# UNITED STATES PATENT AND TRADEMARK OFFICE

10/573,870

<b>Office Action Summary</b>	<b>Application No.</b> 10/573,870	<b>Applicant(s)</b> MITCHELSON, KEITH RICHARD	
	<b>Examiner</b> Charles E. Cooley	<b>Art Unit</b> 1797

## **NON-FINAL OFFICE ACTION**

**FIG. 3**

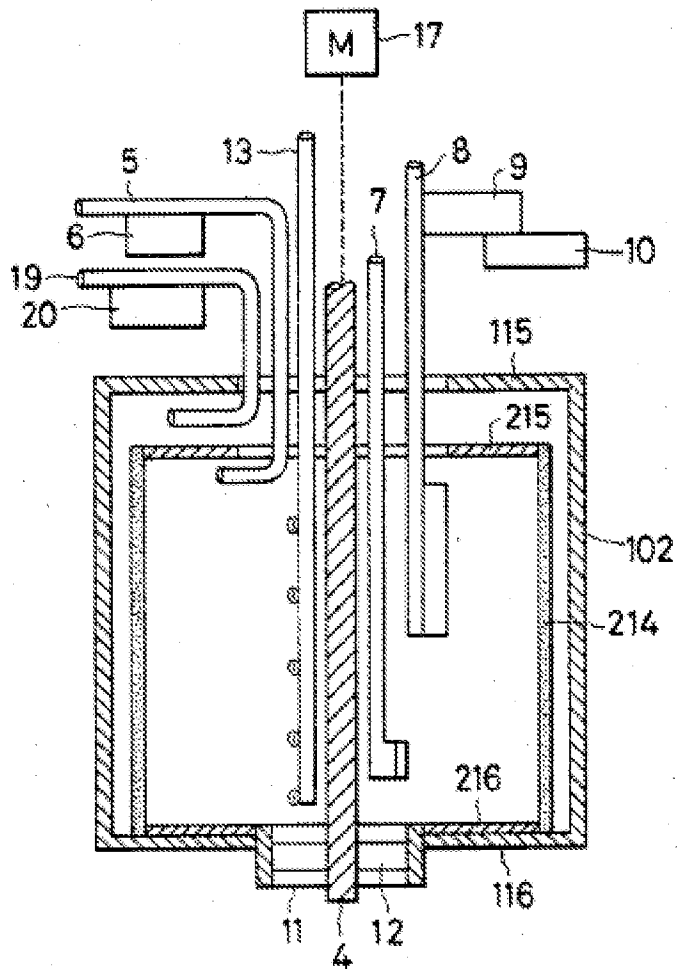
**16. Claims 1-2, 5-7, and 12-21 are rejected under 35 U.S.C. 102(b) as being anticipated by Funabashi et al. (US 4,543,085).**

The patent to Funabashi et al. discloses a separating apparatus in Fig. 3 as depicted below and a method including a circular bowl 102 and/or 214 rotatable about a

central axis and having an opening within 115 and 215 through which the mixture is introduced into the bowl, whereby the rotation of the bowl separates the mixture to form annular rings of the discrete density phases, and a collection assembly 5 and/or 19 for removing the separated discrete density phases, wherein the collection assembly is movable with respect to the bowl via drive 6 or drive 20 such that the collection assembly can be positioned in the bowl to sequentially selectively and individually remove the annular columns from the bowl while the bowl is rotating substantially without disturbing the remaining annular columns within the bowl; wherein the collection assembly is positioned proximal to a surface of the annular column closest to the central axis during removal of the annular column; wherein the collection conduit 5 or 19 is arranged such that the end of the collection conduit extends substantially perpendicular to the central axis of the bowl (Fig. 3); wherein the mixture is introduced into the bowl by means of a delivery conduit 7 inserted into the bowl through the opening of the bowl; wherein a cleaning conduit 13 is inserted into the bowl through the opening to introduce a cleaning solution to the bowl after the separated multiphase mixture is removed from the bowl; the method disclosed at col. 3, line 33 - col. 4, line 25.

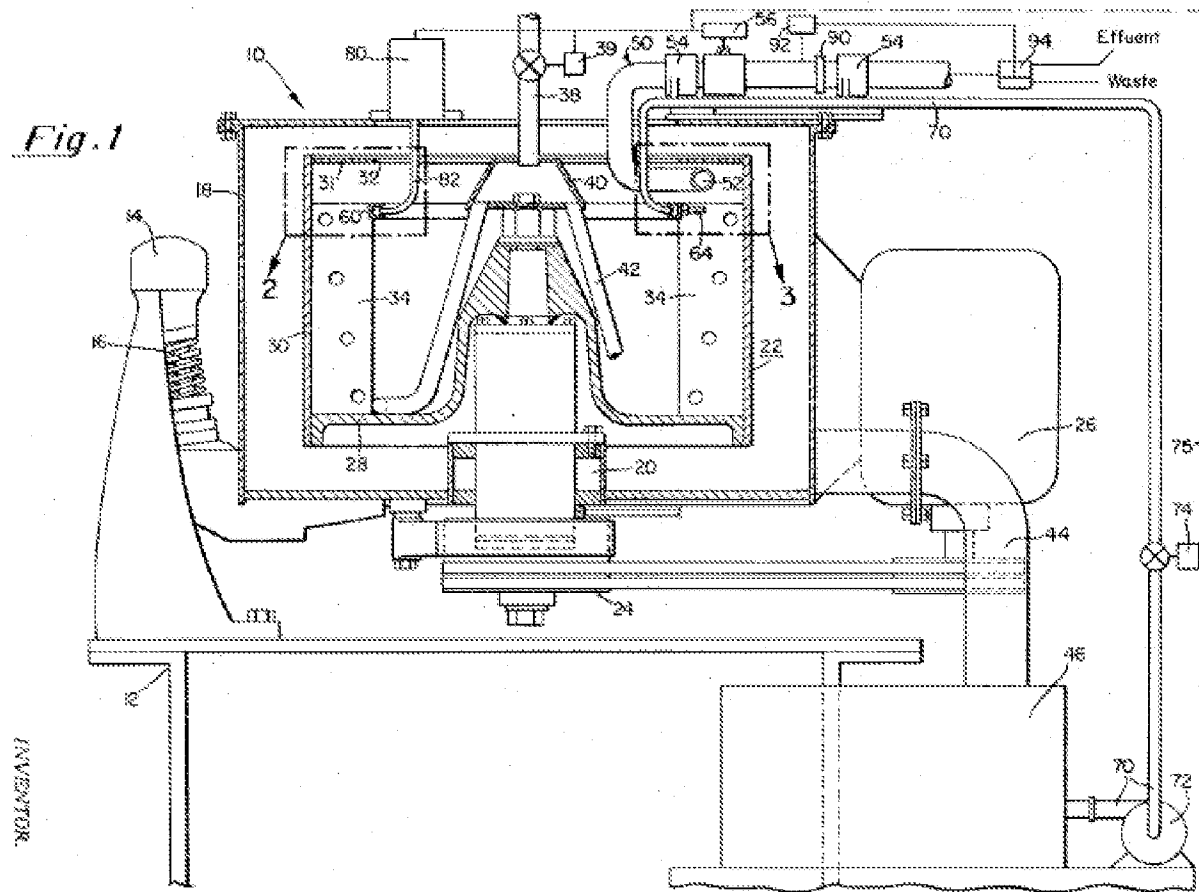
**17. Claims 1-6, 8-19, and 21-25 are rejected under 35 U.S.C. 102(b) as being anticipated by Kirkpatrick (US 3,570,754).**

The patent to Kirkpatrick discloses a separating apparatus as depicted below and a method including a circular bowl 22 rotatable about a central axis and having an opening (proximate 40) through which the mixture is introduced into the bowl, whereby the rotation of the bowl separates the mixture to form annular rings of the discrete density phases, and a collection assembly 50 for removing the separated discrete density phases, wherein the collection assembly is movable with respect to the bowl via drive 56 such that the collection assembly can be positioned in the bowl to sequentially selectively and individually remove the annular columns from the bowl while the bowl is rotating substantially without disturbing the remaining annular columns within the bowl; wherein the collection assembly is positioned proximal to a surface of the annular column closest to the central axis during removal of the annular column; wherein the collection assembly has a collection conduit 52 for collecting at least one annular column inserted into the bowl through the opening and a pump 72; wherein the flow rate of the collection of the annular column from the surface of the annular column is at least the flow rate at which an equivalent volume within the annular column is presented for collection; wherein the collection conduit 52 is arranged such that the end of the collection conduit extends substantially perpendicular to the central axis of the bowl (Fig. 1); wherein the mixture is introduced into the bowl by means of a delivery conduit 38 inserted into the bowl through the opening of the bowl; wherein the introduction of the multiphase mixture into the bowl is by introduction of introducing the separate

components of the mixture separately into the bowl, and the bowl includes a means 34 for agitating and mixing the separate components in the bowl to form a mixture; wherein the means for agitating and mixing the mixture is baffles 34 positioned in the container (Fig. 1); wherein the collecting assembly further includes a waste collecting conduit (proximate 94 in Fig. 1) and a means 60, 80 for identifying the discrete density media or boundary layers formed thereby, and a means 56 to control the movement of the collection assembly such that the movement of the removal means is controllable to allow for the sequential removal from the bowl of each discrete density media by either the collecting conduit or waste collecting conduit; wherein the means for identifying the discrete density media is selected from optical, spectral, electrical conductivity or rheostatic analysis of the discrete density media; the method disclosed at col. 3, line 61 - col. 5, line 29. A multiphase mixture is explicitly taught at col. 5, lines 1-29.

FIG.1

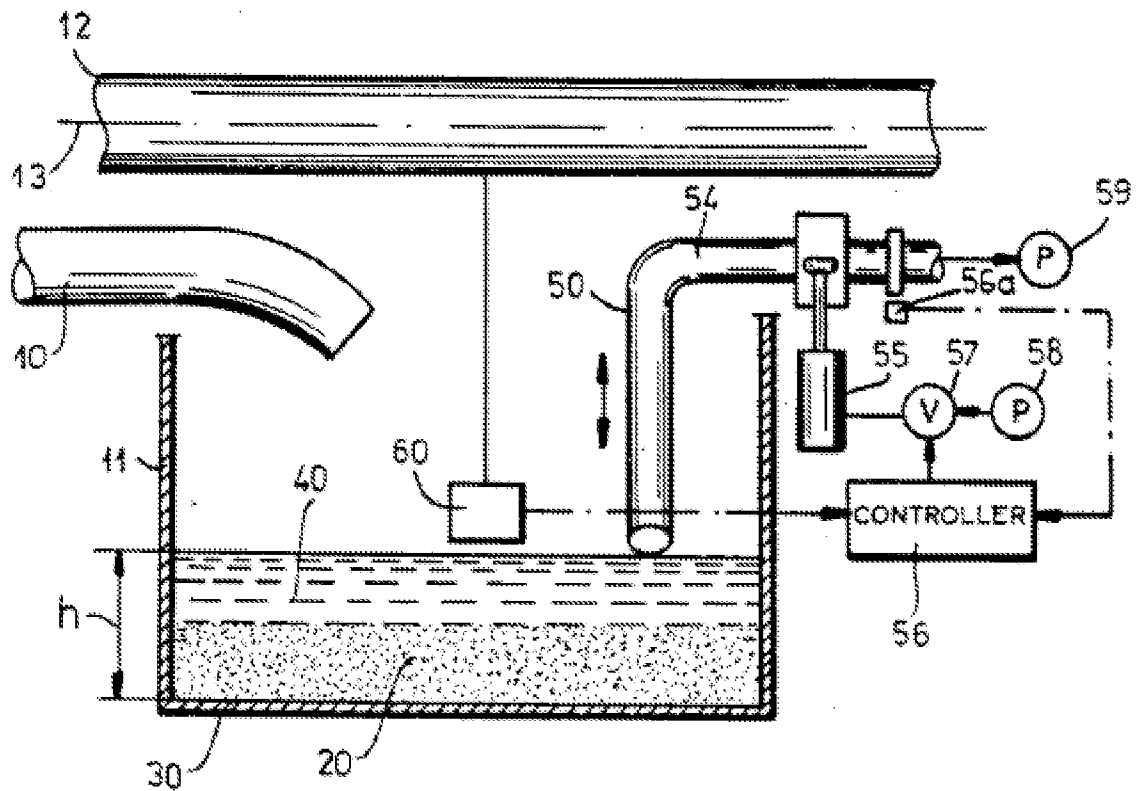
**18. Claims 1-6, 10-19, 21, 24, and 25 are rejected under 35 U.S.C. 102(b) as being anticipated by Buttner et al. (US 5,090,953).**

The patent to Buttner et al. discloses a separating apparatus as depicted below and a method including a circular bowl 11 rotatable about a central axis and having an opening (proximate 10) through which the mixture is introduced into the bowl, whereby the rotation of the bowl separates the mixture to form annular rings 20 and 40 of the discrete density phases, and a collection assembly 54 for removing the separated discrete density phases, wherein the collection assembly is movable with respect to the bowl via drive 55 such that the collection assembly can be positioned in the bowl to sequentially selectively and individually remove the annular columns from the bowl while the bowl is rotating substantially without disturbing the remaining annular columns within the bowl; wherein the collection assembly is positioned proximal to a surface of the annular column closest to the central axis during removal of the annular column (Fig. 1); wherein the collection assembly has a collection conduit 50 for collecting at least one annular column inserted into the bowl through the opening and a pump 59; wherein the flow rate of the collection of the annular column from the surface of the annular column is at least the flow rate at which an equivalent volume within the annular column is presented for collection; wherein the collection conduit 50 is arranged such that the end of the collection conduit extends substantially perpendicular to the central axis of the bowl (Fig. 1); wherein the mixture is introduced into the bowl by means of a delivery conduit 10 inserted into the bowl through the opening of the bowl; wherein the introduction of the multiphase mixture into the bowl is by introduction of introducing the

separate components of the mixture separately into the bowl, wherein the collecting assembly includes a collecting conduit 54 capable of discharging waste material and a means 60 for identifying the discrete density media or boundary layers formed thereby, and a means 55 to control the movement of the collection assembly such that the movement of the removal means is controllable to allow for the sequential removal from the bowl of each discrete density media by either the collecting conduit or waste collecting conduit; wherein the means for identifying the discrete density media is selected from optical, spectral, electrical conductivity or rheostatic analysis of the discrete density media (see col. 4, lines 40-42 that references cited US Patent No. 4,900,453 with this '453 patent teaching the sensor in the form of an electrical conductivity sensor at col. 2, lines 40-41); the method disclosed at col. 4, line 34 - co.. 5, line 30
